CONGRUENT SOFTWARE, INC.
98 Colorado Avenue
Berkeley, CA 94707
(510) 527-3926
(510) 527-3856 FAX

FROM: Peter Johansson
TO: T10 SBP-3 working group
DATE: February 7, 2003
RE: SBP-3 isochronous operations

This document proposes informative and normative text for SBP-3 isochronous operations and completes an idea first put forward at the working group meeting in Huntington Beach, namely that the isochronous transport facilities of SBP-3 could be used with simple devices, e.g., DVD players, printers or scanners, without modification of their command sets if there were a mechanism to associate an isochronous channel (and, in the case of an output stream, speed and maximum data payload) with the data to be transferred.

Figure 8a – Components of an isochronous stream (direct-access logical unit)

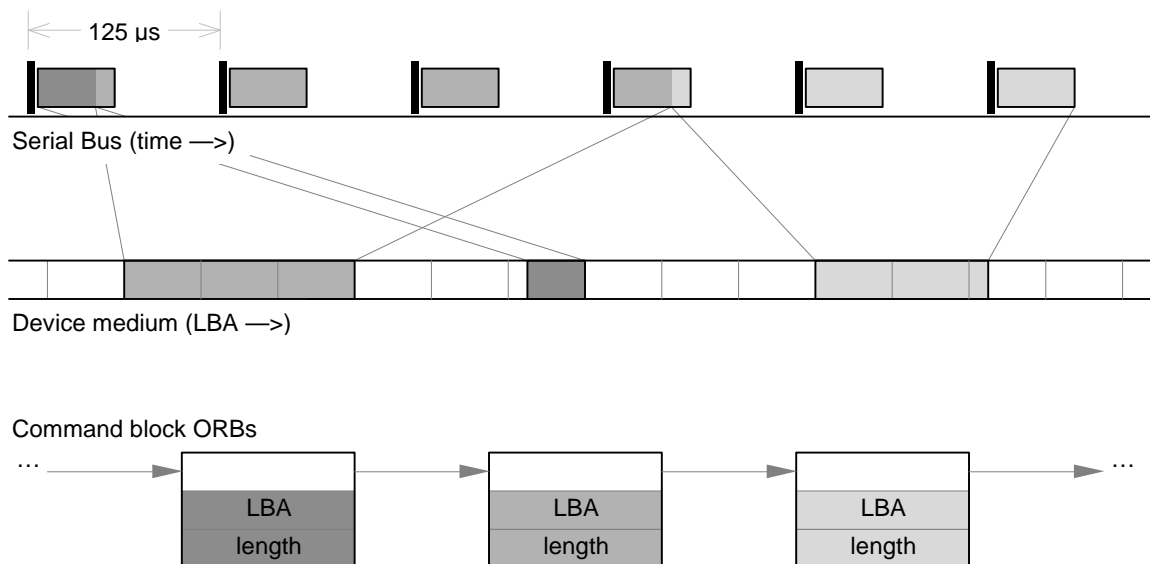
Figure 8a illustrates the relationship between the different stream components during playback (the logical unit is assumed to have direct-access capabilities).

The figure shows that the order of presentation of bytes in a stream is determined by the order of command block ORBs—but that this order is independent of the location of the data on device medium. In this example, the size of the isochronous packet transmitted each cycle is determined by information previously recorded on the medium. The example shows a stream with only one channel (one packet per isochronous period) and a fixed packet size, but streams may consist of more than one channel and the packet size may be different each isochronous period.
